Access Compliance Report

Public Rights-of-Way

(Curb Ramps)

Intersection ID: 29760	Main Street: CREEK_POINTE_DR	Cross Street: FAWN_HILL_RD	Location: NW
ADA ID: ECB996B27E8E	Ramp Type: PerpDiag	Initial Pass/Fail: Fail	Overall Compliance: No
Severity Score: 10			
Codes/Mitigation Info/Possible Solution		Field Measurements/Component Compliance

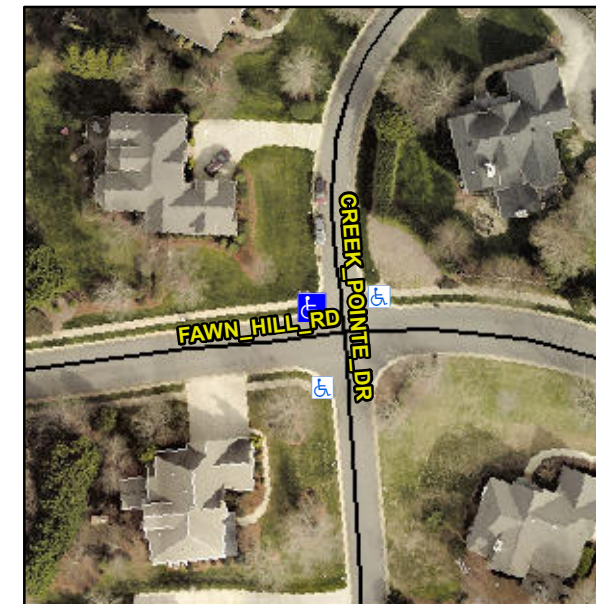
Not Found, R304.5.1, R304.5.3

Compliance	Description	Data	Compliance	Description	Data
N/A	Ramp Length (in)	39.5	Yes	Ramp Slope (%)	6.2
No	Ramp Width (in)	40.0	No	Ramp XSlope (%)	4.3
N/A	Flare Type LT	N/A	N/A	Flare Type RT	N/A
N/A	Flare Slope LT (%)	N/A	N/A	Flare Slope RT (%)	N/A
N/A	Flare Traversable LT?	N/A	N/A	Flare Traversable RT?	N/A
N/A	Landing Length (in)	N/A	N/A	DWS Provided?	N/A
N/A	Landing Width (in)	N/A	N/A	DWS Contrast?	N/A
N/A	Landing Slope (%)	N/A	N/A	DWS Length (in)	N/A
N/A	Landing X Slope (%)	N/A	N/A	DWS Full Width?	N/A
N/A	Landing Curb? (Y/N)	N/A	N/A	DWS Offset (in)	N/A
N/A	Shared Landing?	N/A			
N/A	Gutter Ponding?	N/A	N/A	Gutter Slope (%)	N/A
N/A	Gutter Lip Ht (in)	N/A	N/A	Gutter X Slope (%)	N/A
N/A	Painted X Walk1?	No	N/A	Painted X Walk2?	No
	X Walk 1 Direction	To S		X Walk 2 Direction	To E
N/A	X Walk 1 Width (in)	N/A	N/A	X Walk 2 Width (in)	N/A
	X Walk 1 Slope (%)	0.6		X Walk 2 Slope (%)	4.0
	X Walk 1 X Slope (%)	1.9		X Walk 2 X Slope (%)	0.1

Remove & Replace Curb Ramp With Two New Directional Ramps or Equivalent.
